RE: ^{*Subdivision*} ~~Site Plan Review:~~ ~~35 Barclay Avenue~~ *Castine Avenue*
SIX ~~Three (3) Lots Subdivision~~
Application # ~~2007-0018; CBL 339 D009001~~

I am writing to follow up on the Planning Board Workshop held on April 10th, 2007 and clarify the current status of the Subdivision Review and issues that need to be addressed prior to the project being considered at a Planning Board Hearing.

Subject: Subdivision Plan Submission
Castine Avenue, Portland, Maine

Drawing Name:	Lot Utility Plan
Project:	CASTINE AVENUE, PORTLAND, MAINE
Client:	W&C, LLC PO Box 10127, 449 Forest Avenue, Portland, ME 04104

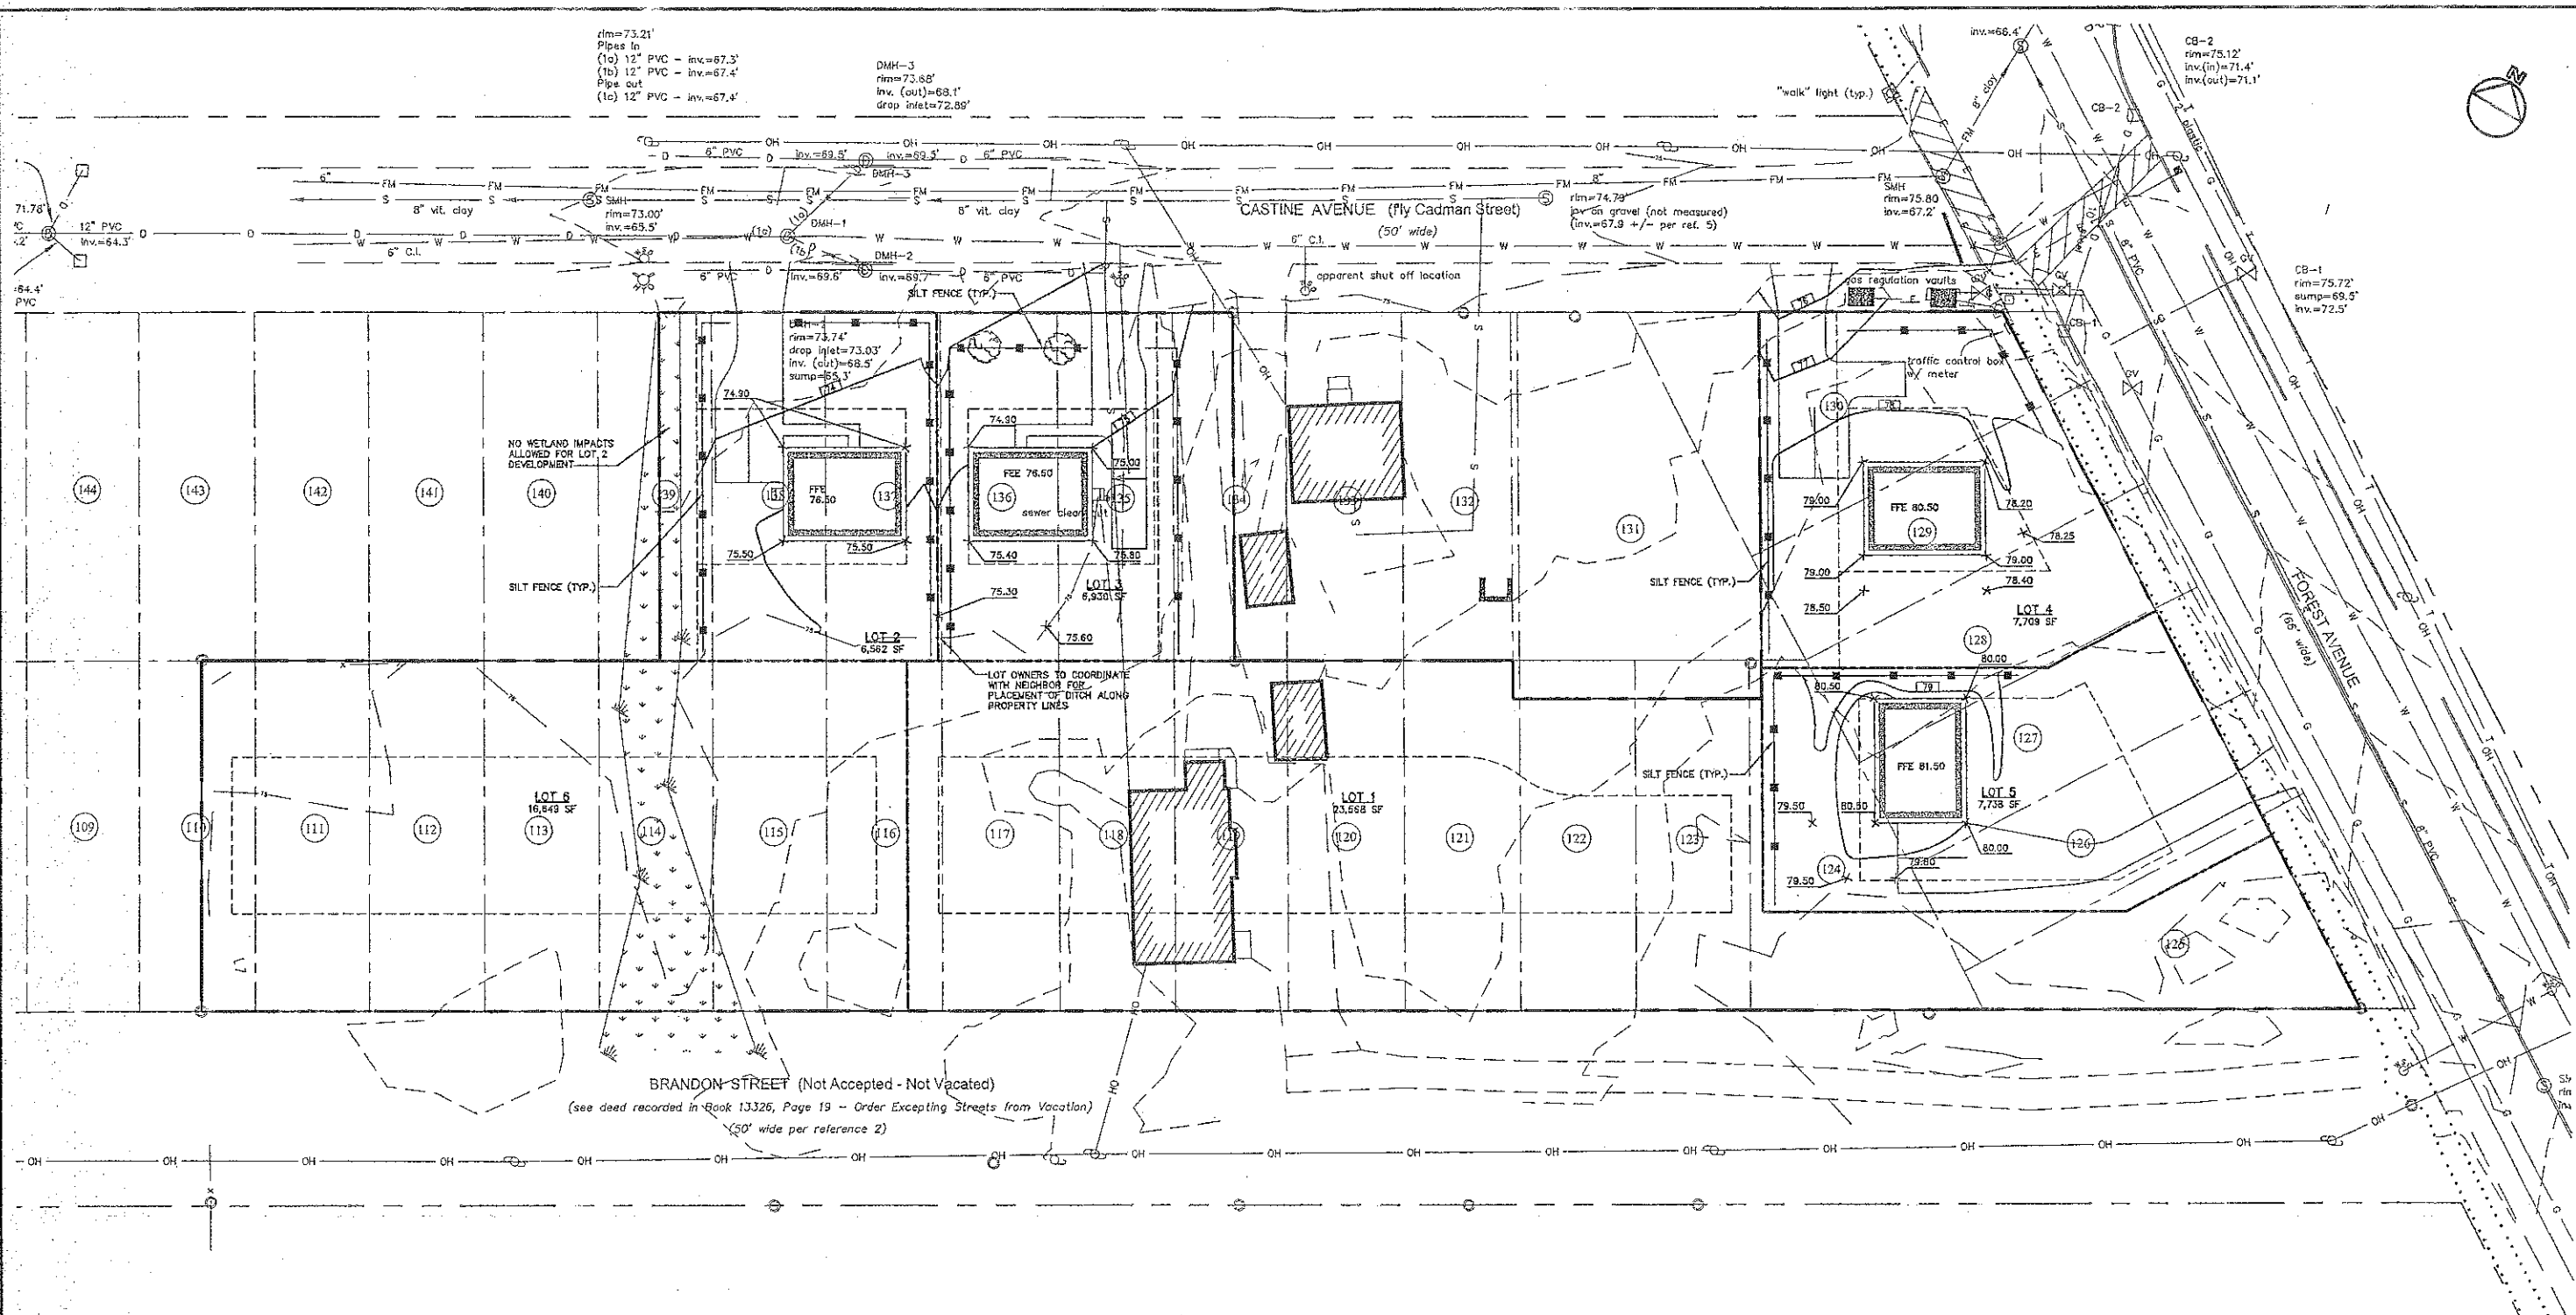
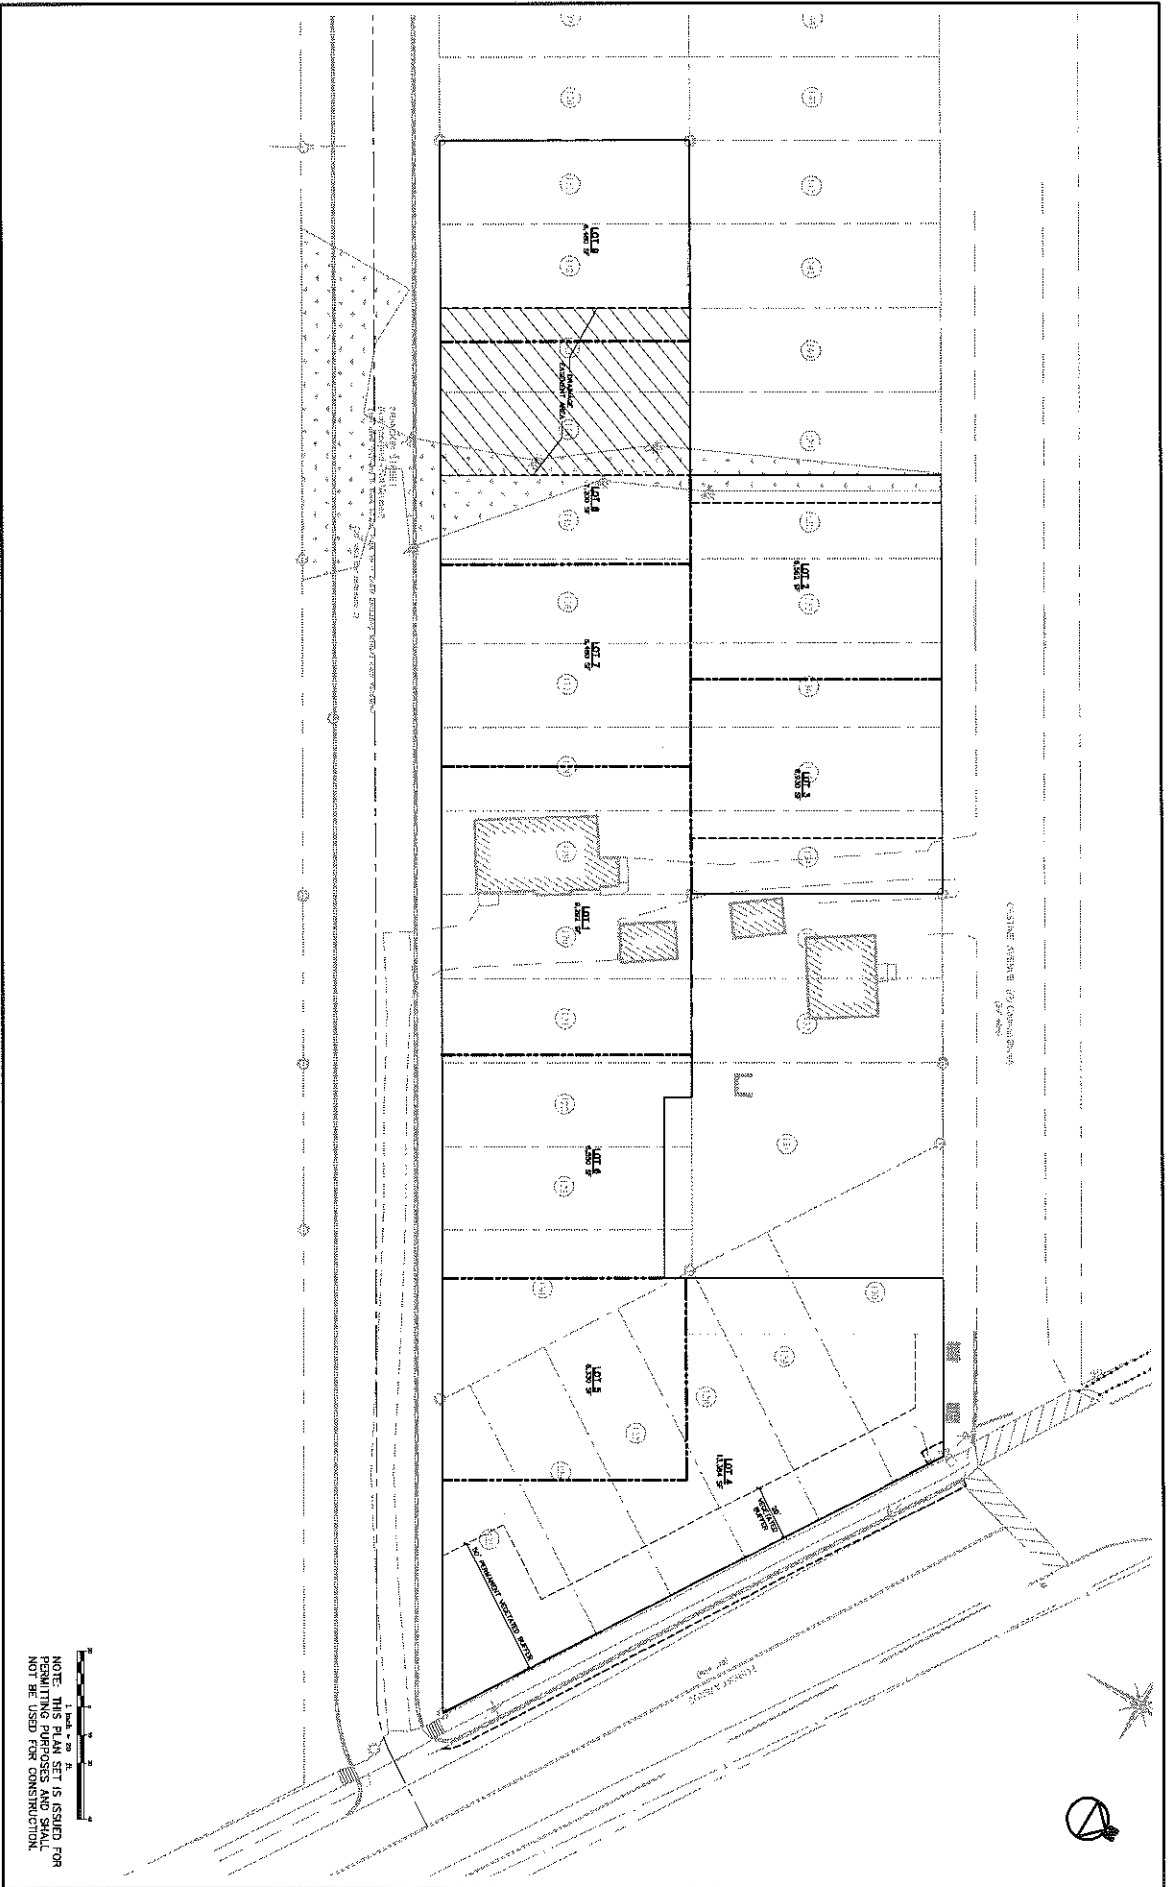
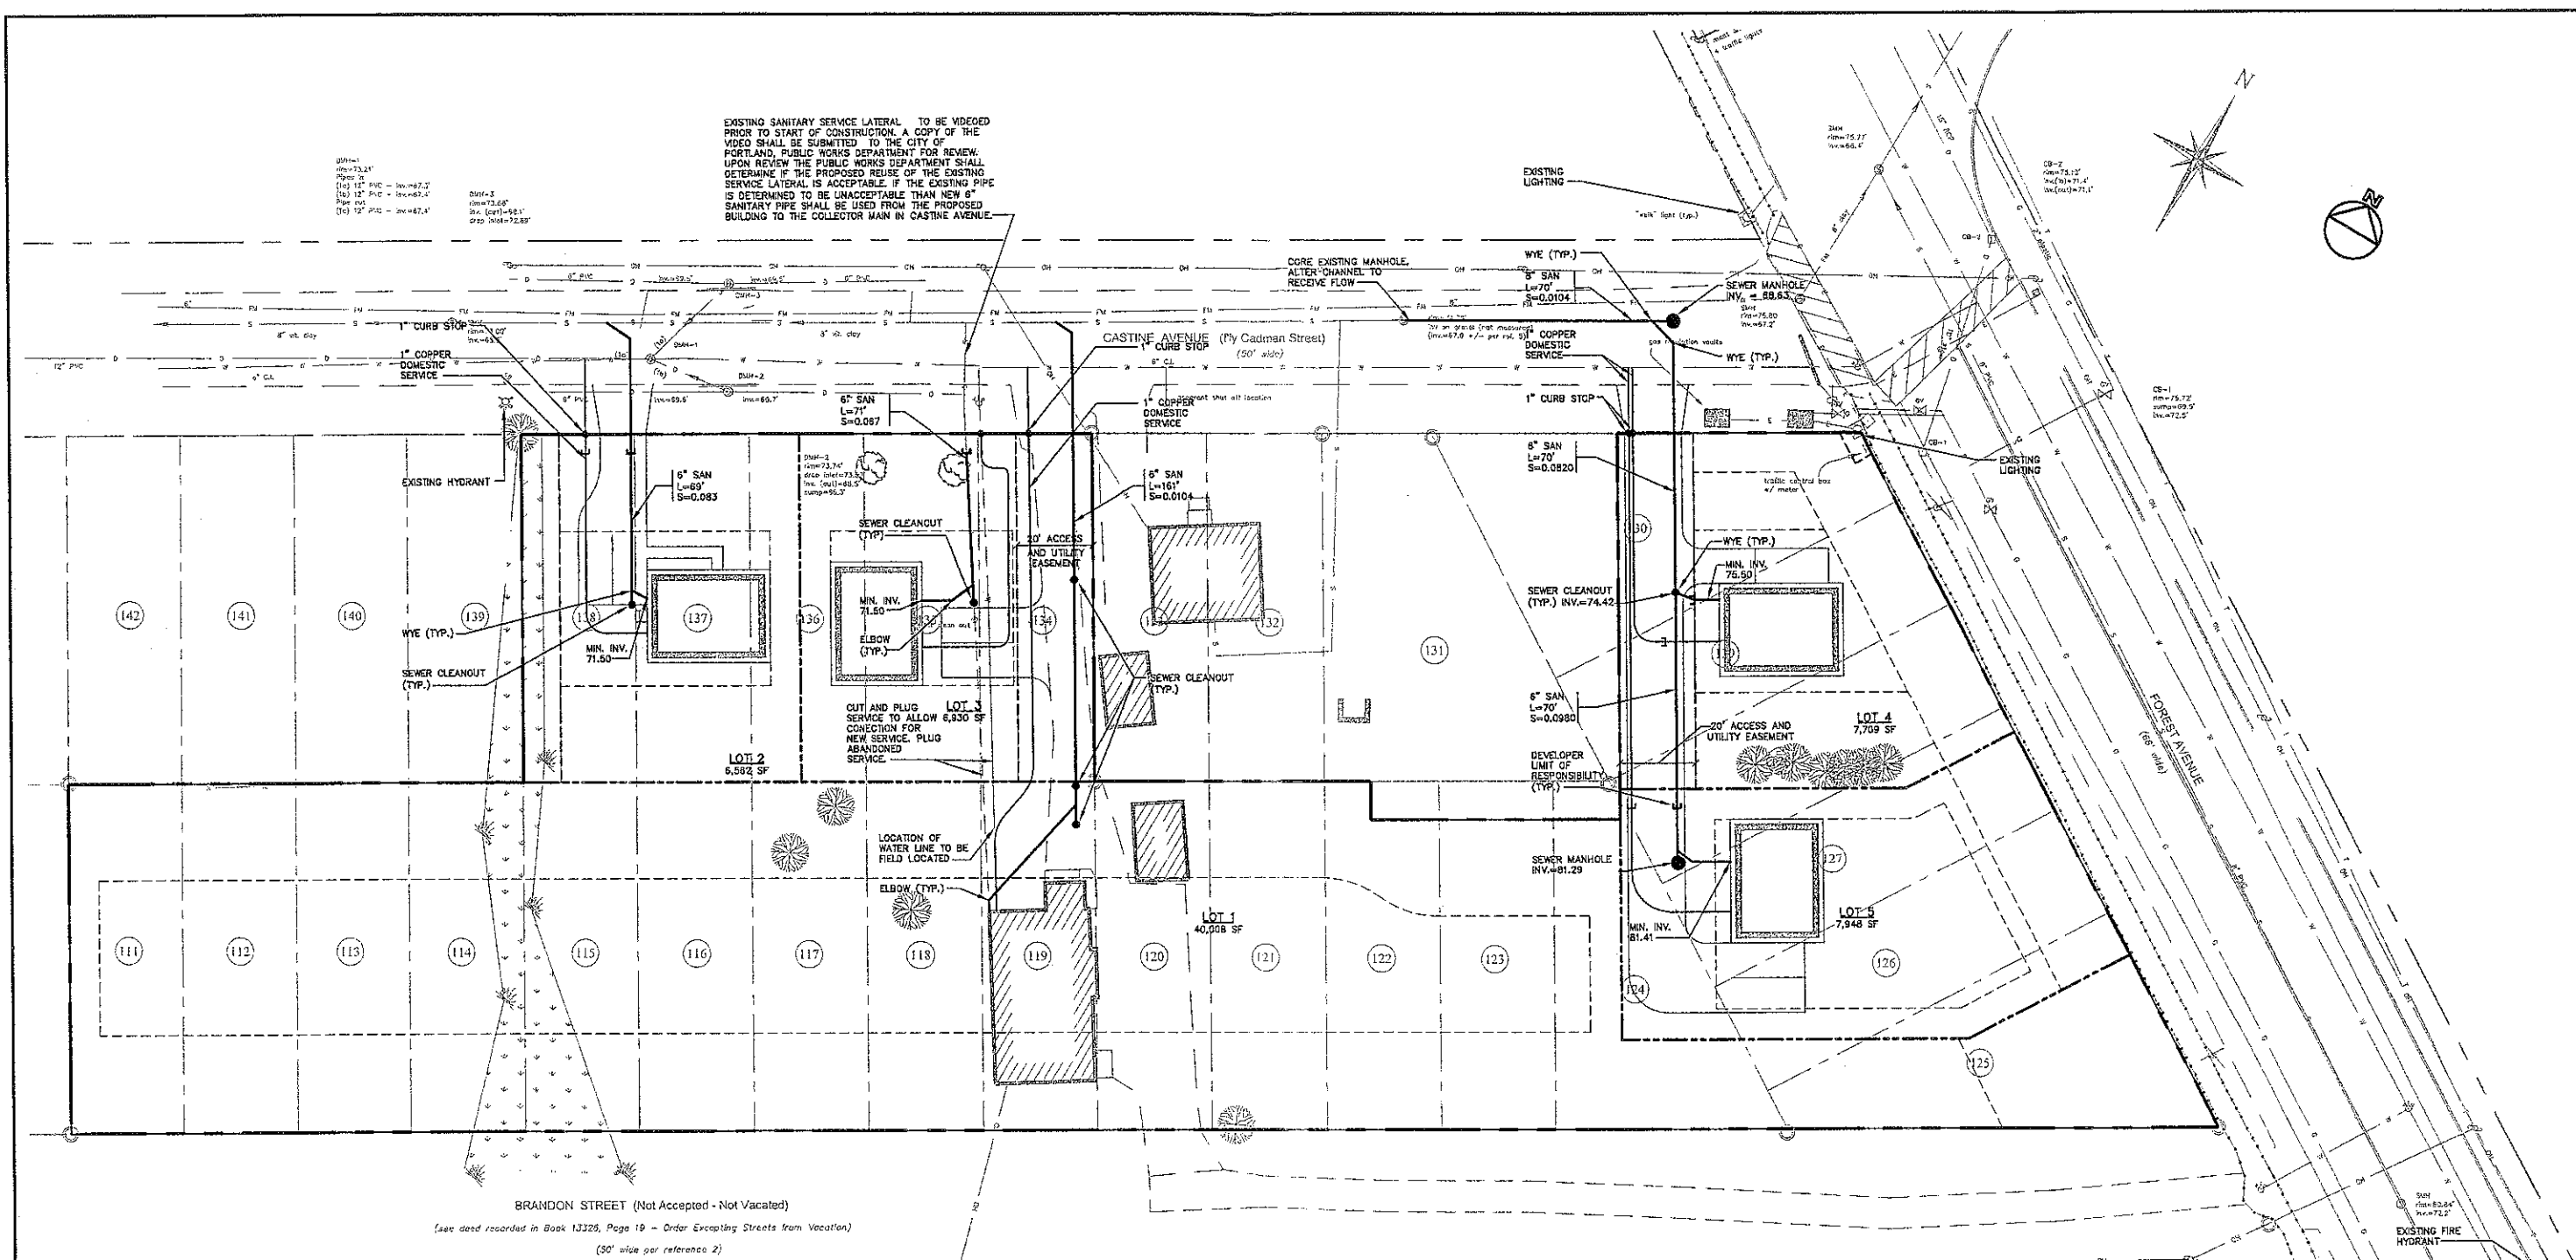
2. Mike Farmer had the following comments pertaining to Sheet 4 of the revised plans:

- *There seem to be some errors on sheet 4 with respect to the proposed sewer elevations on Lots 4 and 5. For example, on lot 5, the sewer elevation is at or above the proposed finished grade elevation near the house.*
- *On lot 2, is it possible to run the sewer lateral out the front of the house to the sewer main, eliminating the pipe elbows and the outside cleanout shown on sheet 4? With gravity sewer systems, straight pipes are generally preferred to pipes one with angles.*
- *I recommend eliminating the proposed outside sewer cleanout on lot 4. I recommend connecting the common sewer for lots 4 and 5 directly to the manhole on the sewer main in the street.*

Please revise sheet 4 to reflect the above comments prior to the Public Hearing.

2. There seem to be some errors on sheet 4 with respect to the proposed sewer elevations on Lots 4 and 5. For example, on lot 5, the sewer elevation is at or above the proposed finished grade elevation near the house.

3. On lot 2, is it possible to run the sewer lateral out the front of the house to the sewer main, eliminating the pipe elbows and the outside cleanout shown on sheet 4? With gravity sewer systems, straight pipes are generally preferred to pipes one with angles.

The sewer inverts on sheet 4 have been revised. The sewer location on lot 2 has been revised. The sewer cleanout has been deleted for lots 4 and 5 and the sewer now connects to the manhole in the street.

Response 2 – The sewer inverts on Sheet 4 have been revised. The sewer location on lot 2 has been revised. The sewer cleanout has been deleted and the sewer connects to the manhole in the street. Revised plans are included with this letter.
